<b>DART AEROSPACE LTD</b>	<b>Work Order:</b> 84681
<b>Description:</b> Crosstube Assembly, Mid Fwd	<b>Part Number:</b> D206-667-147TRN
<b>Inspection Dwg:</b> D206-667-147 Rev: A	<b>Page 1 of 1</b>

A	NEW ISSUE	CP	10.11.23
REV.	DESCRIPTION	BY	DATE
DESIGN	<u>90</u>	DART AEROSPACE LTD	
DRAWN	<u>90</u>	HAWKESBURY, ONTARIO, CANADA	
CHECKED	<u>1</u>	DRAWING NO.	REV. A
MFG. APPR.	<u>1</u>	D206-667-147	SHEET 1 OF 4
APPROVED	<u>1</u>	TITLE	SCALE
DE APPR.	<u>1</u>	CROSSTUBE ASS'Y (206L MID FWD)	NTS
DATE	10.12.23	COPYRIGHT © 2010 BY DART AEROSPACE LTD THIS DOCUMENT IS PRIVATE AND UNCLASSIFIED AND IS SUPPLIED ON THE EXPRESS CONDITION THAT IT BE NOT TO BE USED FOR ANY PURPOSE OR COPIED OR COMMUNICATED TO ANY OTHER PERSON WITHOUT WRITTEN PERMISSION FROM DART AEROSPACE LTD.

DRAWING NO. D206-667-147	TITLE CROSSTUBE ASS'Y (206L MID FWD)	REV. A	DART AEROSPACE LTD ENGINEERING ORDER		D.E.O. NO. D206-667-147-A-1	SHEET NO. SHEET 1 OF 1	SCALE NTS
DRAWN 9	CHECKED ASS	MFG. APPR. [Signature]	APPROVED [Signature]		DE APPR. [Signature]		
DATE 11.07.15	DATE 11.07.20	DATE 11.07.21	DATE 11/07/21		DATE 11.07.21

REPLACE MAGNOBOND WITH PROSEAL.

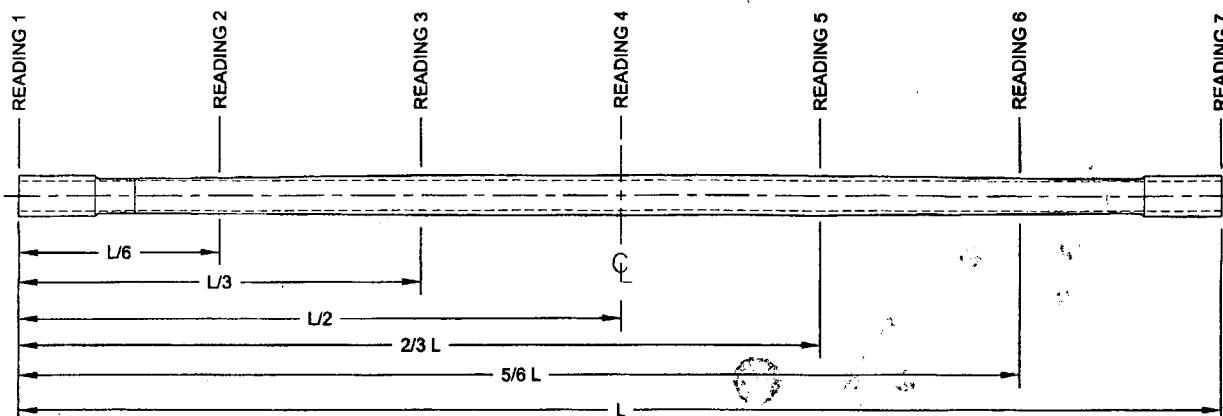
NOTE 12 & 15, SHEET 1 IS AMENDED AS FOLLOWS:

- 12) TO INSTALL D2891-1 SUPPORT: ABRABE MATING SURFACE OF SUPPORT AND CROSSTUBE WITH 180-GRIT SANDPAPER AND REMOVE RESIDUE WITH MEK (OR EQUIVALENT). APPLY A 0.04" TO 0.07" THICK LAYER OF PROSEAL 890 CLASS B-2 (OR AMS-S-8802 CLASS B-2) SEALANT TO MATING SURFACE OF SUPPORT.
- 15) TORQUE CLAMPS 80 TO 100 IN-LB. ENSURE AT LEAST 1.5 THREADS SHOWING IN SAFETY AND THAT NUT HAS NOT BOTTOMED-OUT AFTER TORQUING. **PRIOR TO PACKAGING, RE-CHECK TORQUE ON CLAMPS AFTER PROSEAL 890 SEALANT HAS CURED FOR 72 HOURS.**
